Response to Kirklees Ref: K14-9SE/10 dated 5 August 2024

Fearnley Street / Fall Lane, Dewsbury

Visibility Splays

Drawing Number	Rev
161464-001	-

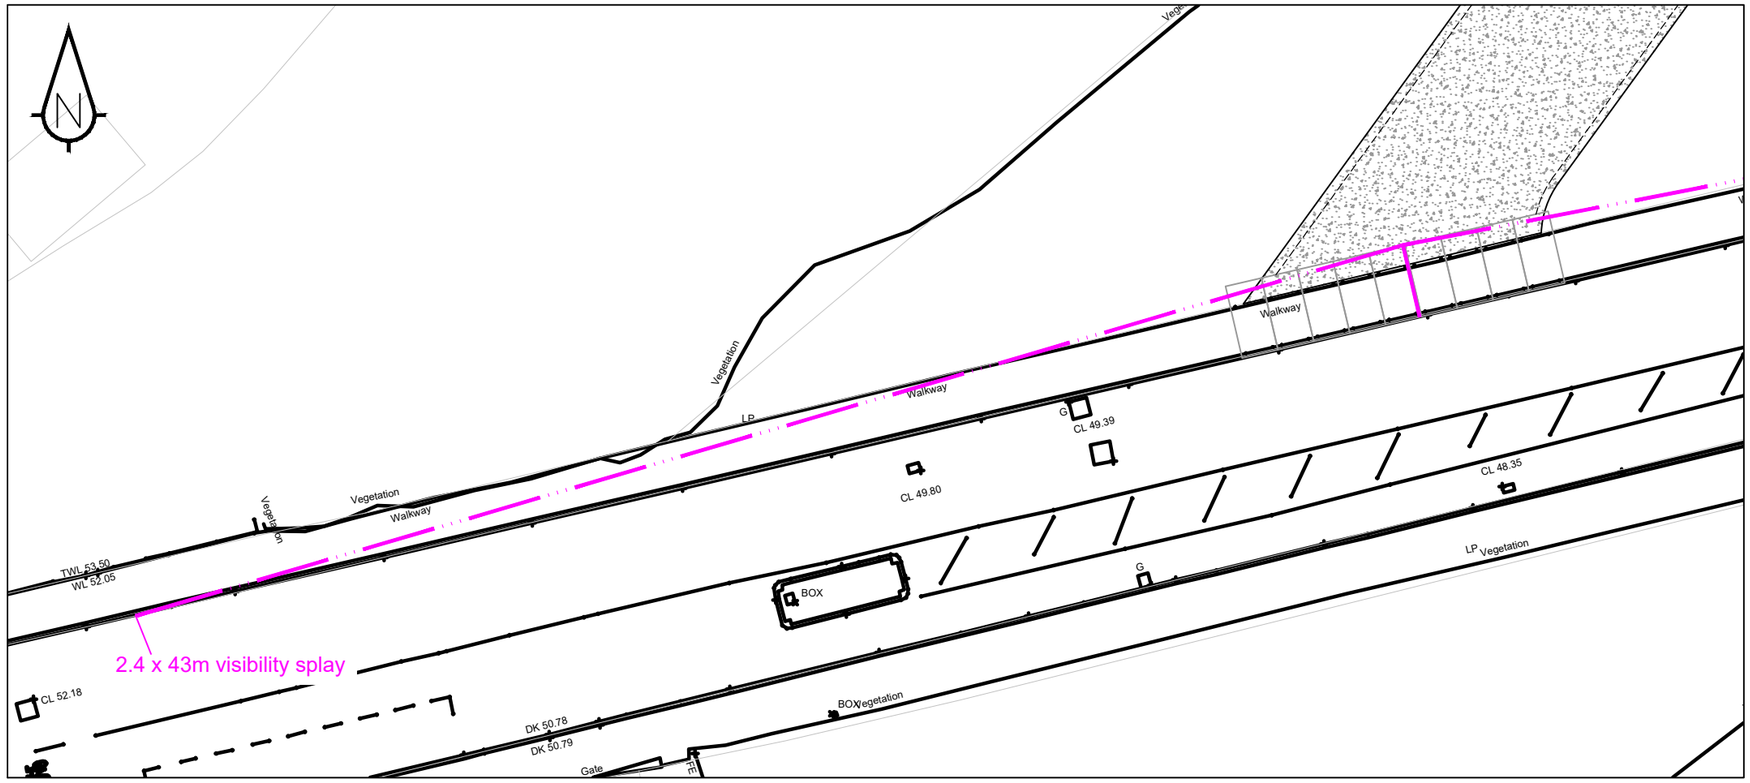
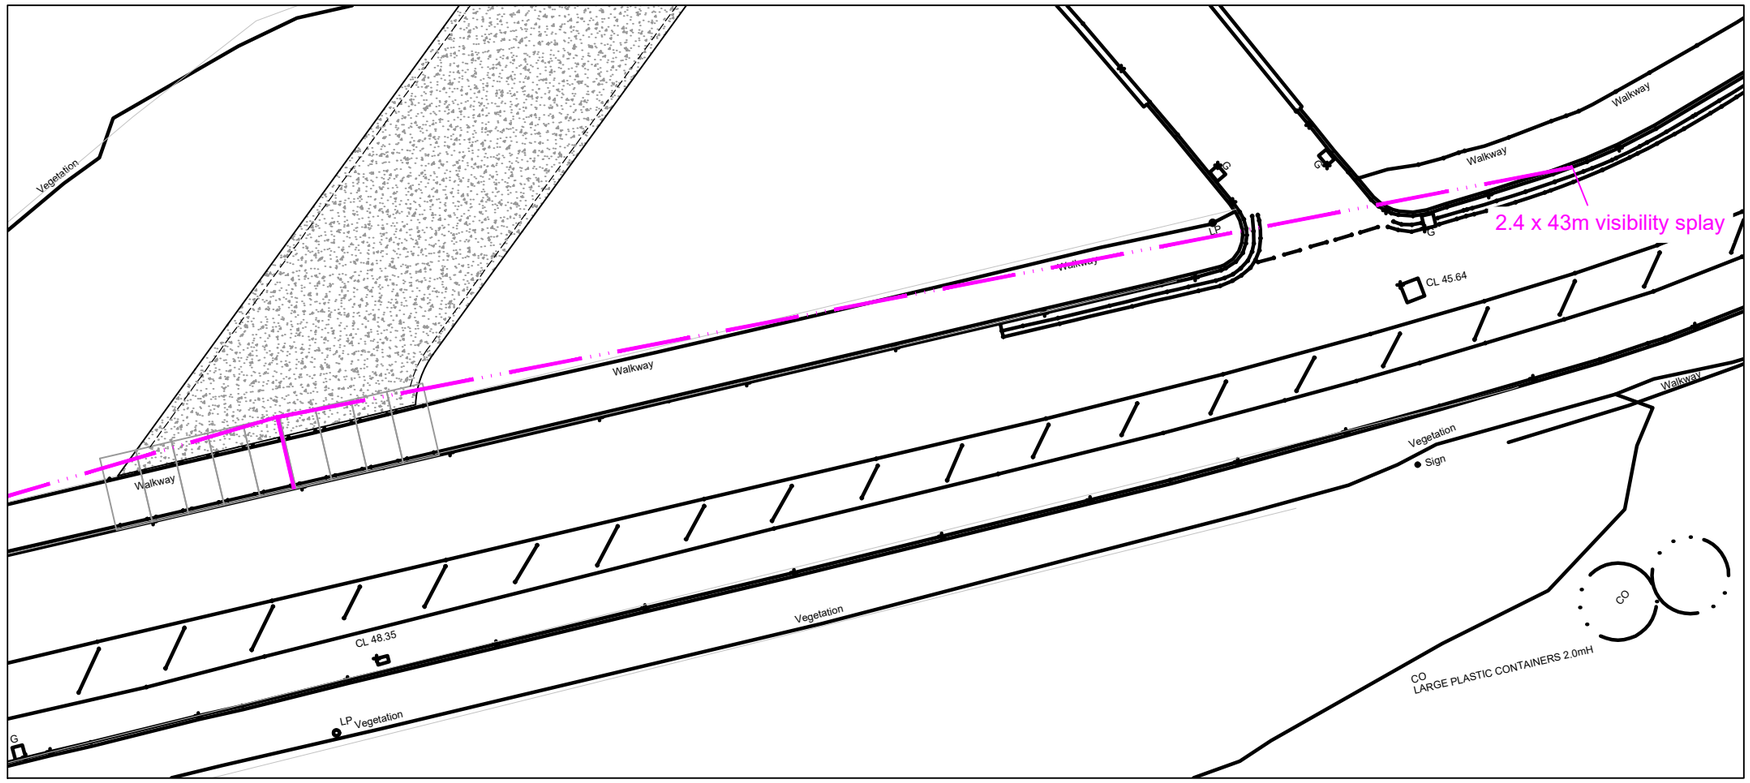
Kirklees Comments	**Applicant Response**
Junction Visibility; to address this element of the condition the submission includes a series of photographs, whilst these are a visual representation they are not acceptable to address the requirements of the condition. The achievable visibility splays should be clearly shown and measured on a plan in the industry standard format, as set out in Manual for Streets (Section 7.7 – Visibility Splays at Junctions), with an 'X' distance of 2.4m.	Visibility splay details are provided in page 2 of this document – Drawing Ref 161464-001
